**CITY OF WINTER PARK  
PLANNING AND ZONING BOARD**

**Staff Report  
July 11, 2017**

**REQUEST OF DESHPANDE, INC. FOR:** APPROVAL OF THE FINAL PLAT TO CREATE A 30 LOT, RESIDENTIAL SINGLE FAMILY SUBDIVISION FROM PROPERTIES ON ELLEN DRIVE AND COUNTRY CLUB DRIVE, ZONED R-2.

CENTRAL LIVING ORLANDO  
WOODCREST DRIVE  
WINTER PARK, FL  
Proj. No.: 2953  
Lot:  
Blk:  
Job No.:  
Sect:  
Sect:

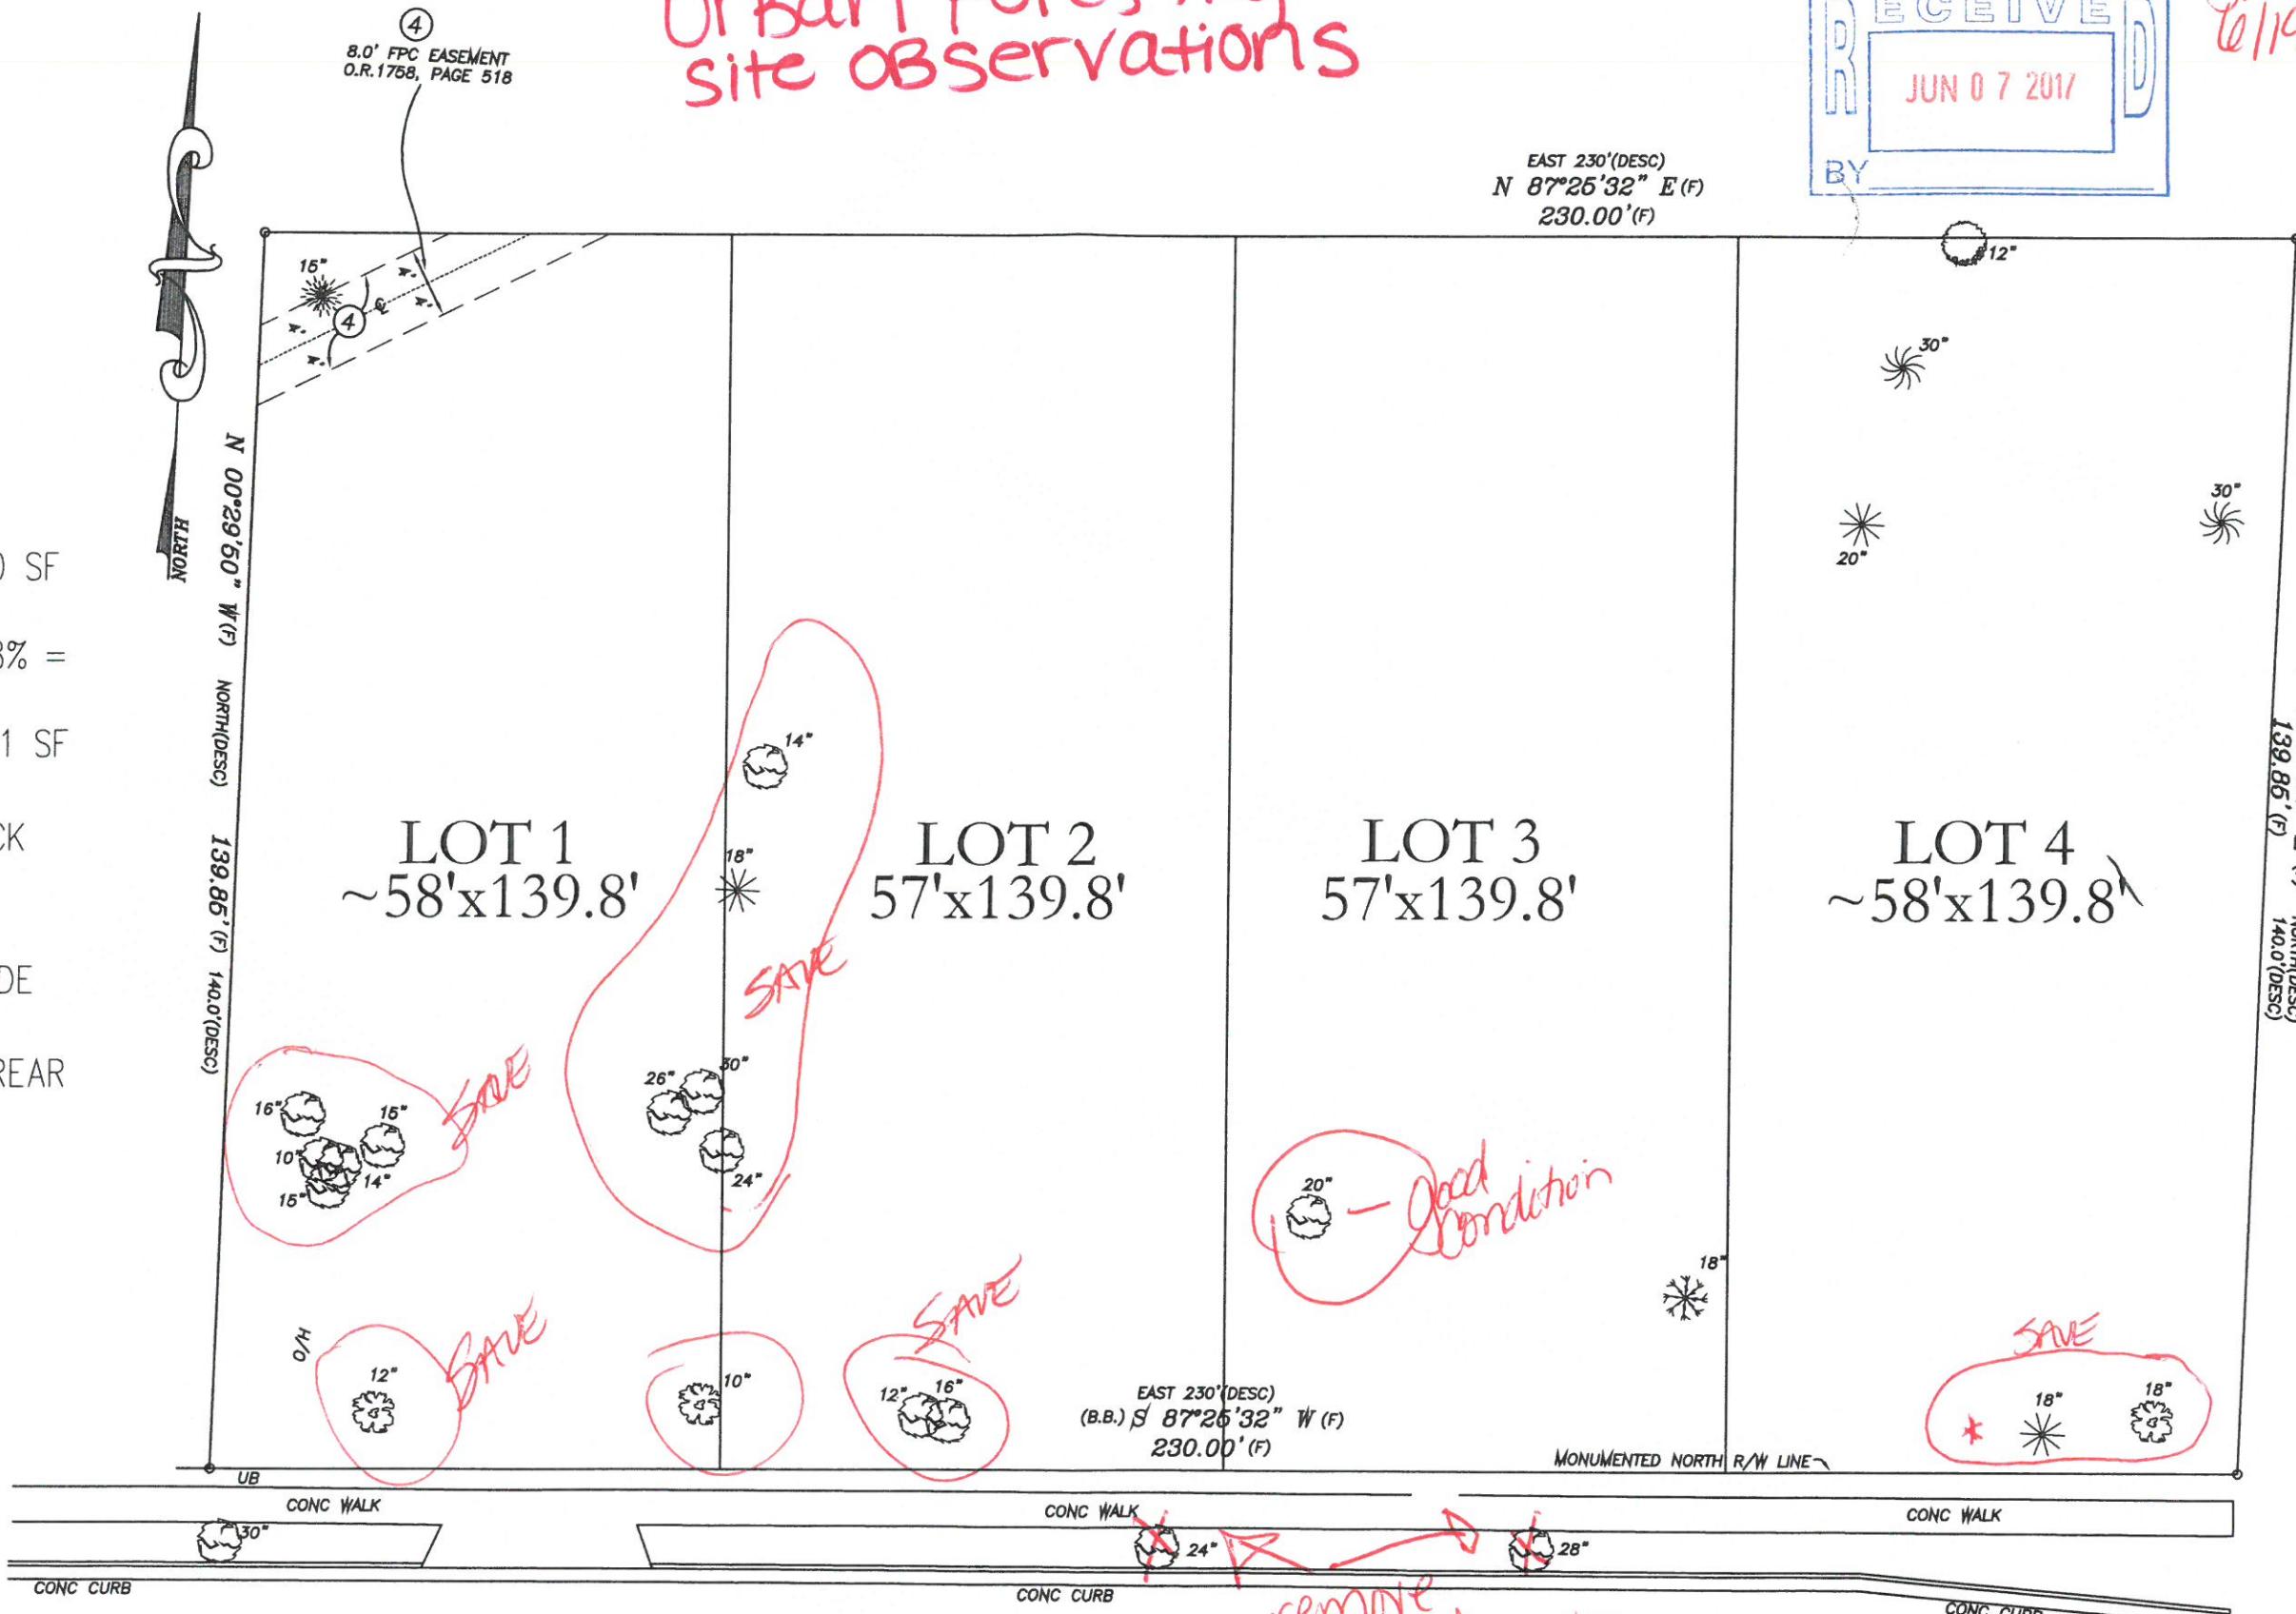
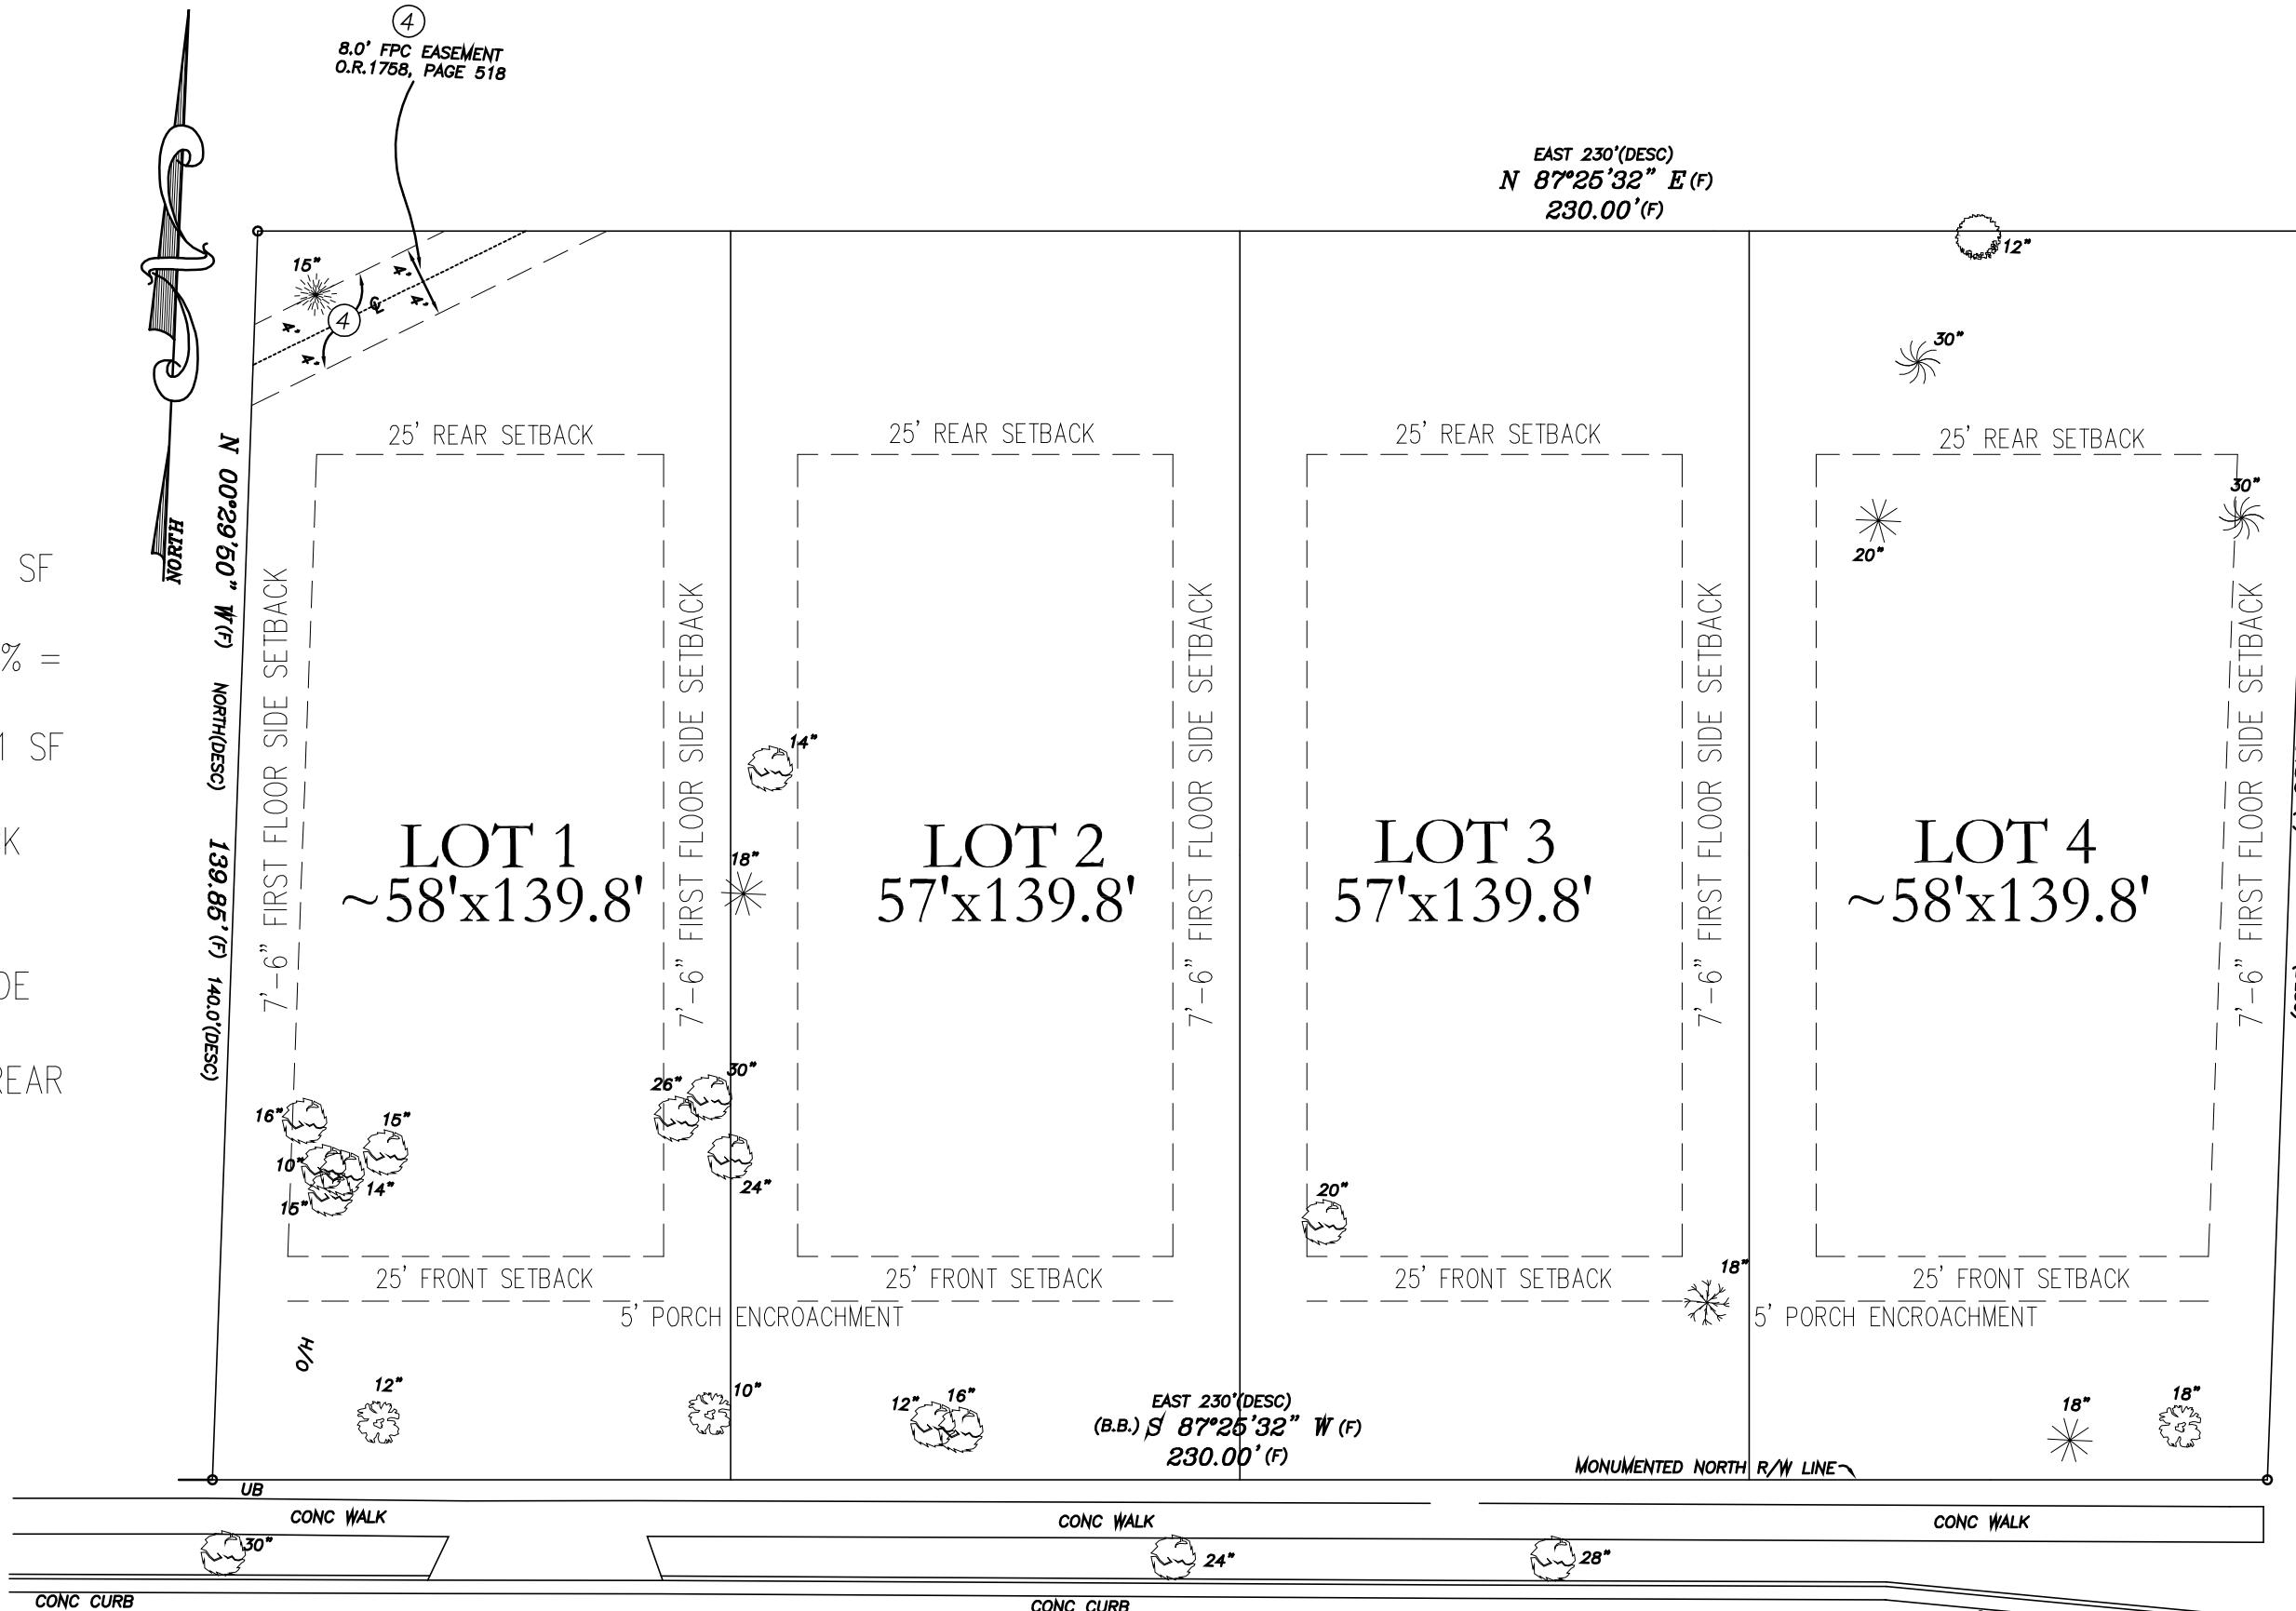
**DEVELOPMENT PLANS:** The applicant has provided a generalized front elevation for the type of homes that they plan to build, and general site plans for the layout of the proposed new homes. Staff is recommending that a condition be placed that these homes be of varying architecture as the applicant has presented.

**TREE PRESERVATION:** The City's Urban Forester has reviewed this application, and provided comments (attached) that show the request to save almost all of the trees in the front portion of the lots. Planning staff realizes that it may be unrealistic to request that the applicant save all of these trees, but would support interior side setback variances, up to five feet, in order to save trees that the Urban Forester has requested be saved that are within the building footprint.
